Temperature Control — Trim Air System

Air Conditioning — Trim Air System — Conversion to the Standard 2 Zone Regulation Configuration

Object code	DMC-ZPH-A-21-60-11-00A-700A-A	**Issue**	002-00 (revised)
Issue date	2026-08-07	**Language**	en-GB
Responsible partner	AERALIS S.A.S. (U8025)	**Originator**	AERALIS S.A.S. — In-Service Engineering, Valmont (U8025)
Security	01 — Unclassified	**Quality assurance**	First verification (tabtop)
Applicability	ZEPHYR-20 and ZEPHYR-22 and ZEPHYR-24, all aircraft, post MOD-150422

Service bulletin number	ZPH-21-1218
ATA chapter	21-60-11
Compliance category	sbcc02
Task category	sbtc03
Original issue date	2020-02-11

Temperature Control — Trim Air System — location, side view — Figure 1

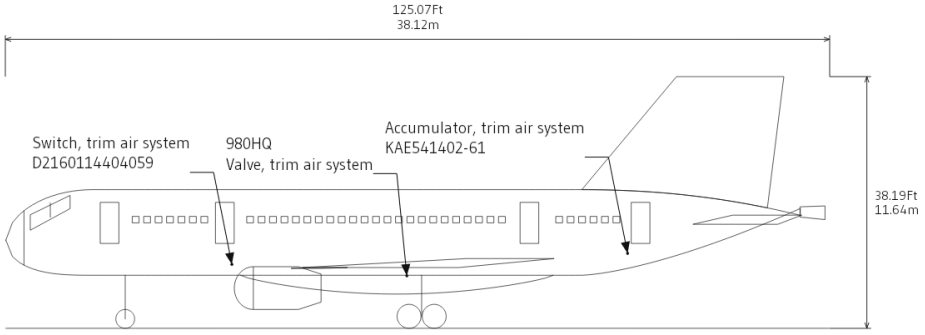
This Service Bulletin converts the trim air regulation to standard 2. Each zone valve is replaced by the switched assembly that carries a sensor boss on its outlet flange, an accumulator is installed upstream of each valve to damp pack transients, and the zone controller parameter set is re-scaled to the new loop gains. On ZEPHYR-24 aircraft a third sensing point is added for the forward zone. The distribution ducting itself is not replaced.
